UNITED STATES PATENT AND TRADEMARK OFFICE

10/763,115

Office Action Summary	Application No. 10/763,115	Applicant(s) LIM, ROY K.	
	Examiner Michael B. Priddy	Art Unit 3733

DETAILED ACTION

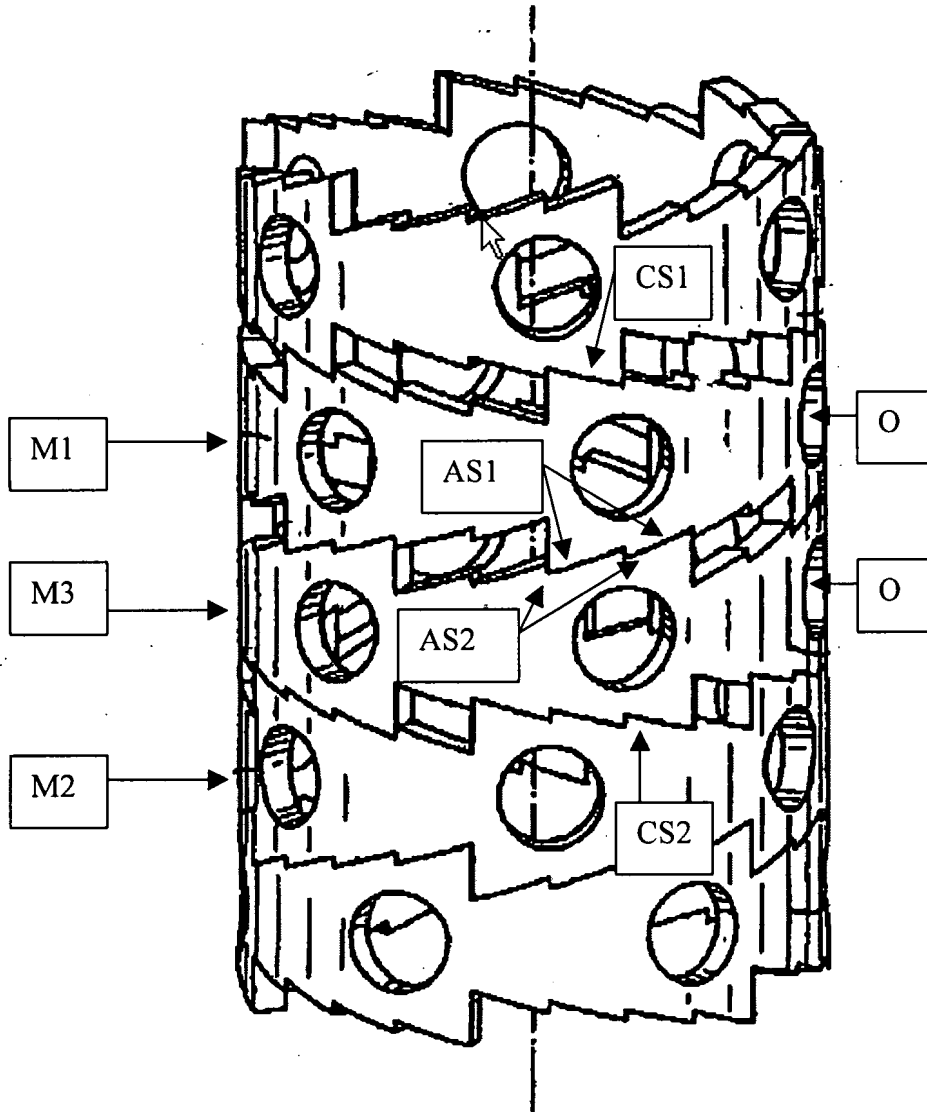
Claims 1, 11, 20, 25, 27, 29, 31 are rejected under 35 U.S.C. 102(a) as being anticipated by Conchy (FR 2,817,463) with reference to the figure below. Conchy teaches a device to space vertebral members comprising: a first member M1 having an interior side with first and second angled sections AS1 and an exterior side with a first contact surface CS1; a second member M2 having a second interior side and a second exterior contact surface CS2; a third member positioned between the first member and the second member, the third member M3 having a first side with first and second angled sections AS2 positioned towards the angled sections AS1 of the first member M1, and a second side positioned towards the interior surface of the second member M2, the device positionable between a first orientation with the angled sections of the first member disengaged from the angled sections of the third member M3 and having a first height extending between the first contact surface CS1 and the second contact surface CS2, and a second orientation (shown) having the angled sections AS1 of the

first member M1 engaged with the angled sections AS2 of the second member M2 and having a second height between the first contact surface CS1 and the second contact surface CS2, with the second height being greater than the first height.

Claims 32, 37, 38 and 46 are rejected under 35 U.S.C. 103(a) as being unpatentable over Conchy (With reference to the aforementioned figure) in view of Brantigan (US 4,787,915). Conchy teaches a device to space vertebral members comprising: a first member M1 and a second member M2 each having an exterior side CS1/2 and an interior side, the interior sides having ramped surfaces AS1/2 positioned at an angle relative to the exterior sides, the device positionable between a first

orientation with the ramped surfaces AS1/2 disengaged and having a first height extending between the exterior surfaces CS1/2, and a second orientation (shown) having the ramped surfaces AS1/2 engaged and having a second height between the exterior surfaces CS1/2, with the second height being greater than the first height.

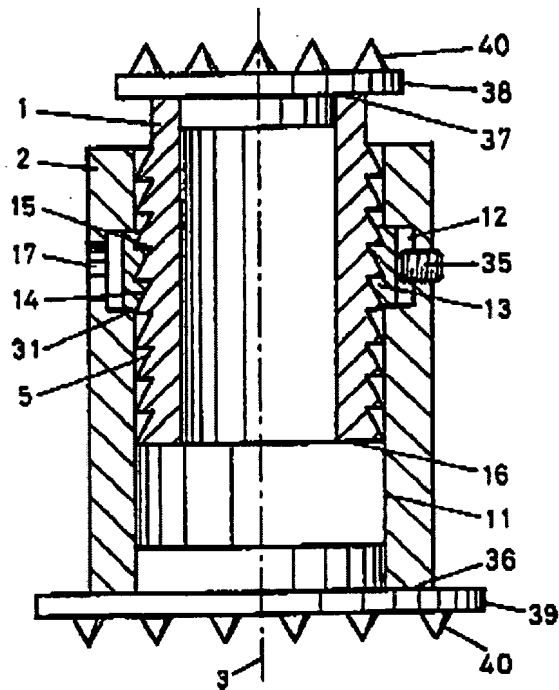
Claims 1, 3, 5, 7, 11, 20 and 21 are rejected under 35 U.S.C. 102(b) as being anticipated by Schär et al. (US 6,176,881) with reference to the figure below. Schär et

al. teach a device to space vertebral members comprising: a first member 1 having an interior side with a plurality of first angled sections 5 and an exterior side 38 with a first contact surface; a second member 2 having a second interior side and a second exterior contact surface 39; a third member 13 positioned between the first member 1 and the second member 2, the third member 13 having a first side with a plurality of second angled sections 14 positioned towards the first angled sections 5, and a second side positioned towards the interior surface of the second member 2; the device positionable between a first orientation with the first angled section disengaged from the second angled section and having a first height extending between the first contact surface 38 and the second contact surface 39, and a second orientation having the first angled sections engaged with the second angled sections and having a second height between the first contact surface 38 and the second contact surface 39, with the second height being greater than the first height; wherein the first contact surface 38 and the second exterior contact surface 39 are substantially parallel in the first orientation; further comprising a locking mechanism 35 extending outward from the third member 13 and having at least one extension that mounts within an aperture 17 in the second member 2 when the device is positioned at the second orientation; wherein the second member 2 is positioned towards a proximal end of the first member 1 in the first position, and positioned towards a distal end of the first member 1 in the second position.
